London Borough of Wandsworth

Wandle Delta Masterplan Supplementary Planning Document – Public Consultation (March 2021)

Schedule of Representations and the Council's Responses

Figure 1.1 – Homebase Development Footprint

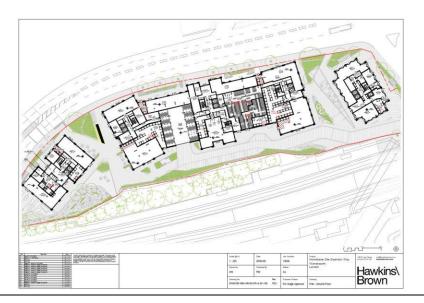
The development footprint of the Homebase site was also amended as part of the S73 application (ref. 2020/0011). **Figure 48 Consented proposals for Swandon Way sites** should therefore be updated to reflect the correct building footprint which is approved by the S73 application. This is shown in Figure 1.1 (Homebase Development Footprint) below.

Figures throughout the SPD where the Homebase site is shown should also be updated to ensure conformity with the consented proposals within the Swandon Way Cluster.
